## ARCHITECT'S SUPPLEMENTAL INSTRUCTION NO. 1

**DATE:** February 16,  
2024

**RE: Civil and MEP  
revisions**

**Streets of West Pryor – Lot 13**

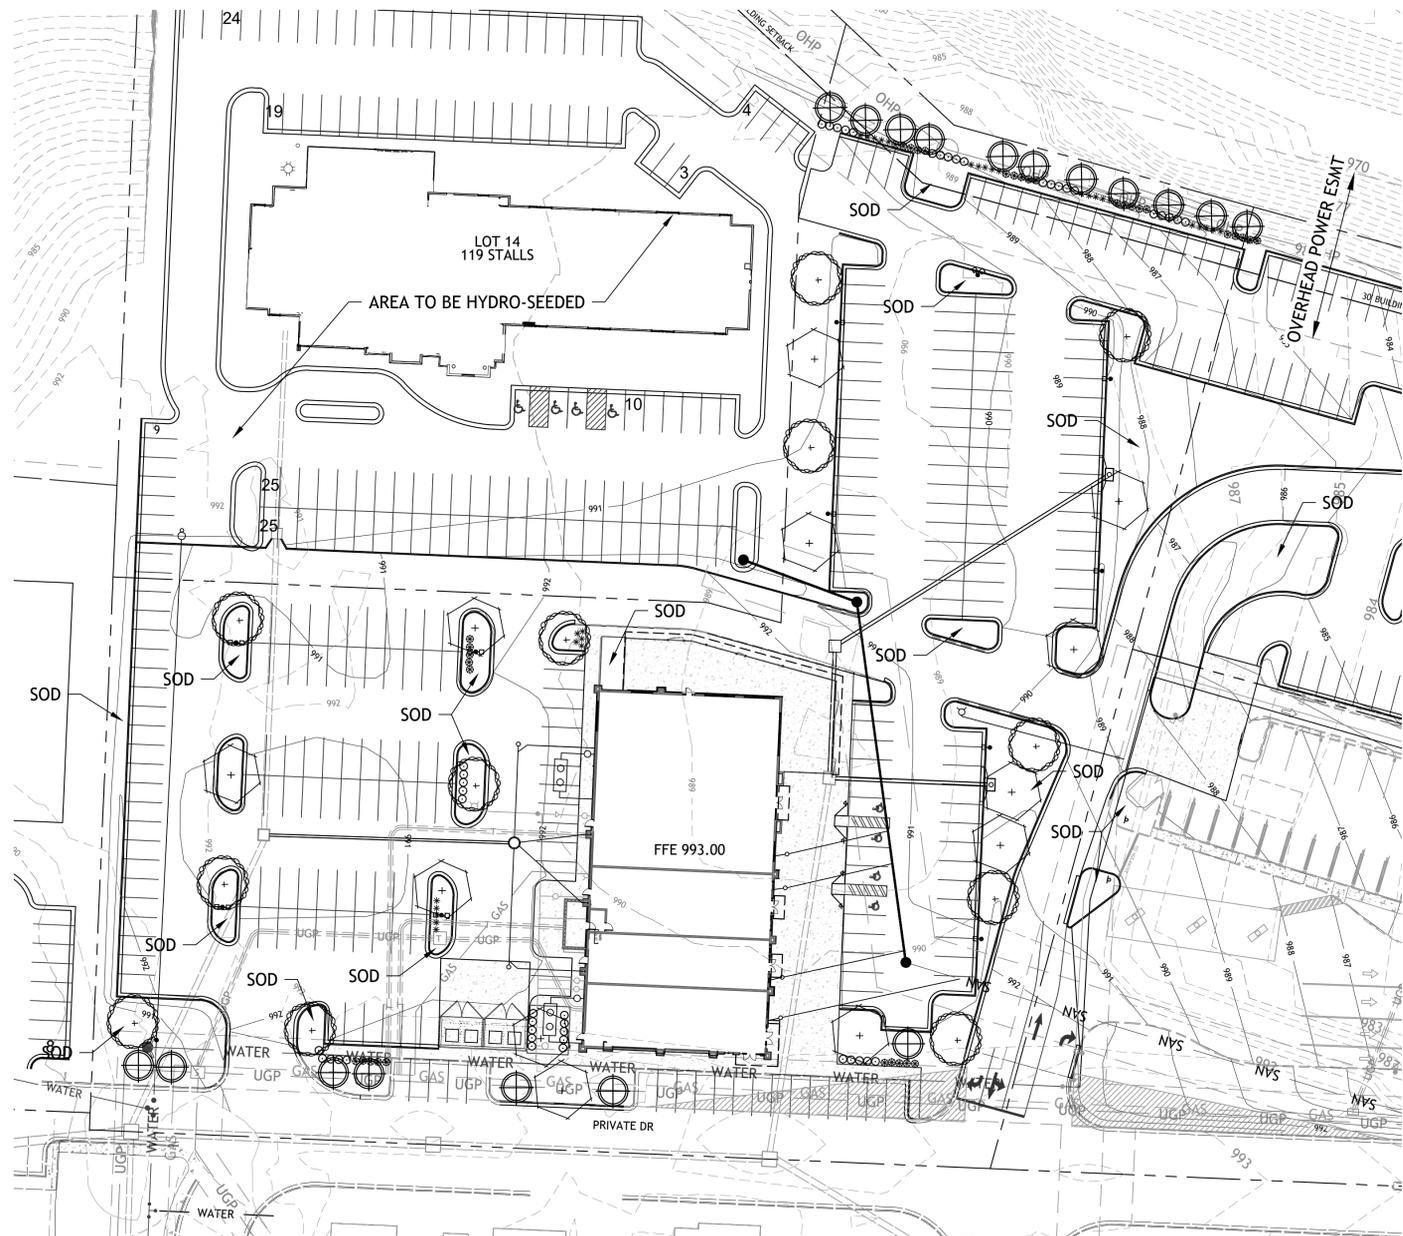
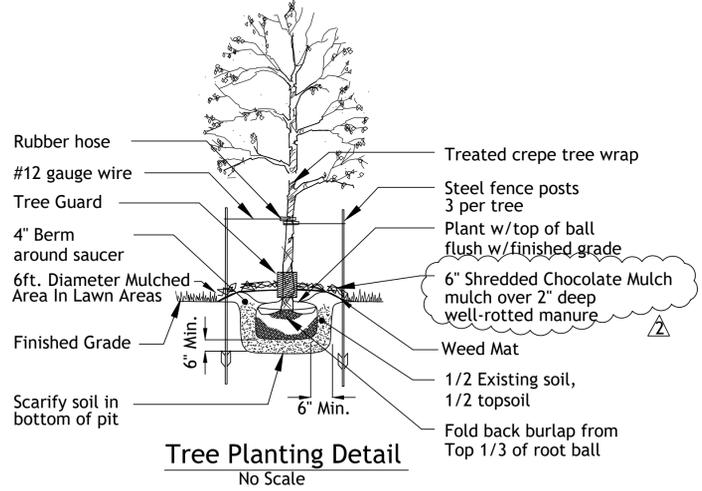
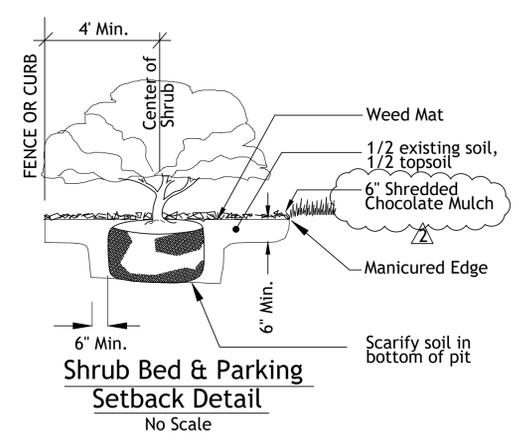
**Item C1: Tree and Mulch type revised . See attached Civil sheets**

All shrub beds shall be mulched with 3" of shredded chocolate mulch.

SHEET TITLE  
SITE LIGHTING  
PLAN

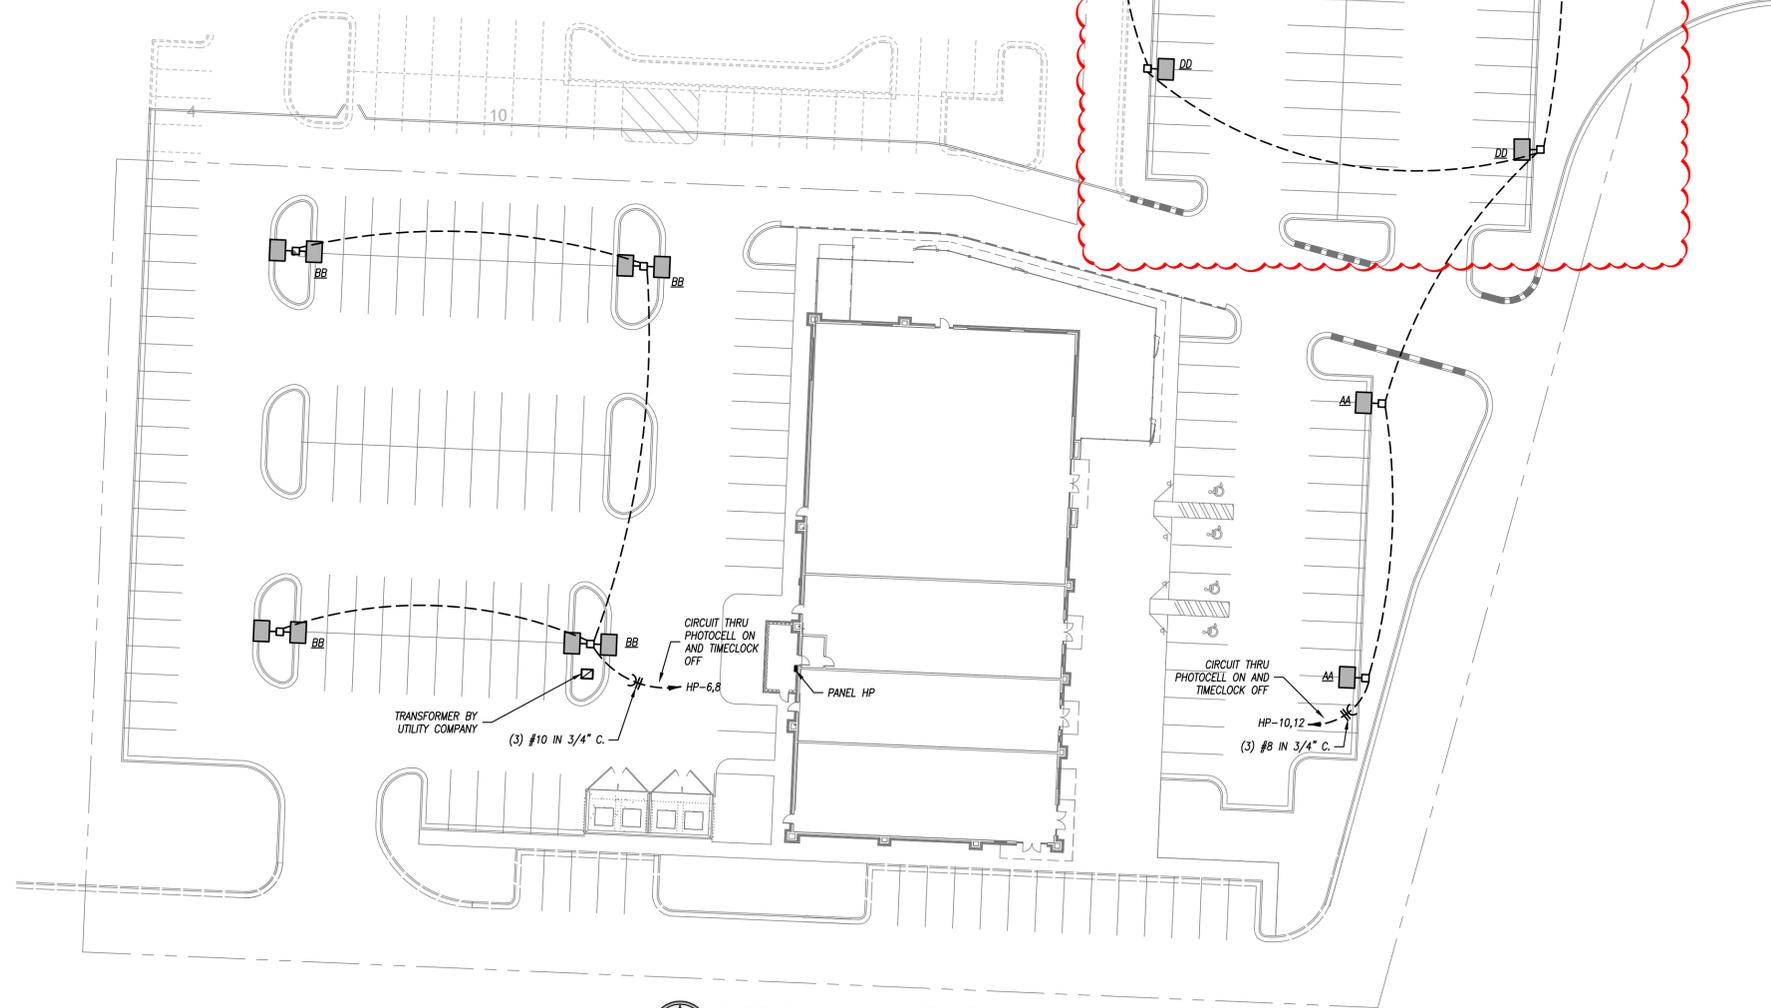
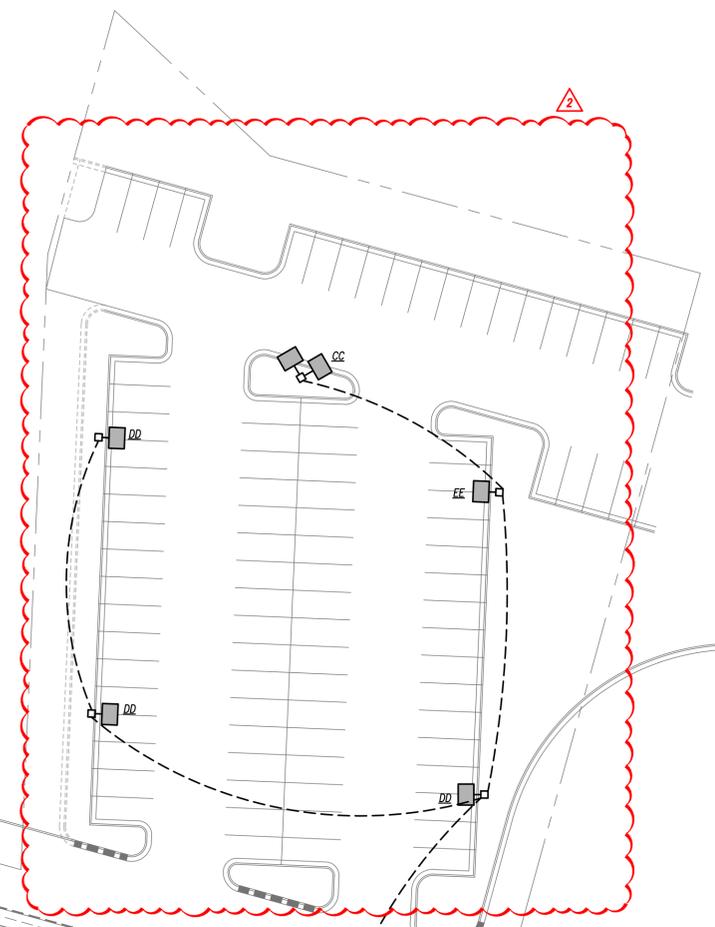
**Item M1: Updated Photometrics. See attached MEP sheets**
